GLASTAR SERVICE BULLETIN 22

MANDATORY

Subject: AN470A3-4.5 soft rivets

Applicability: GlaStar tail kits shipped between 1/1/97 and 3/1/97, inclusive (kit serial numbers 5096, 5319, 5367, 5368, 5370–5374, 5376, 5377, 5380–5384, 5386–5392, 5394–5414, 5416–5426, and three other tail kits for which kit serial numbers were not issued)

Figure 1

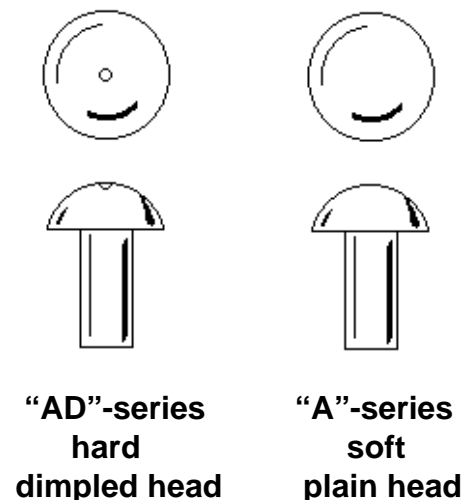
Required Action: First, inspect your supply of AN470AD3-4.5 rivets and **remove** all the soft, "A"-series rivets. They can be distinguished from the "AD"-series rivets by the heads. As shown in Figure 1, the standard, "AD"-series rivets have a small dimple in the center of the head, while the soft, "A"-series rivets have plain heads.

Second, inspect any completed work on your GlaStar tail surfaces to see if any soft, "A"-series rivets were used. If you discover any soft rivets, **you must drill them out and replace them** with proper AN470AD3-4.5 rivets. If necessary, refer to "SECTION II: TOOLS AND TECHNIQUES" in the *GlaStar Assembly Manual* to refresh your memory on the proper procedure for replacing soft rivets.
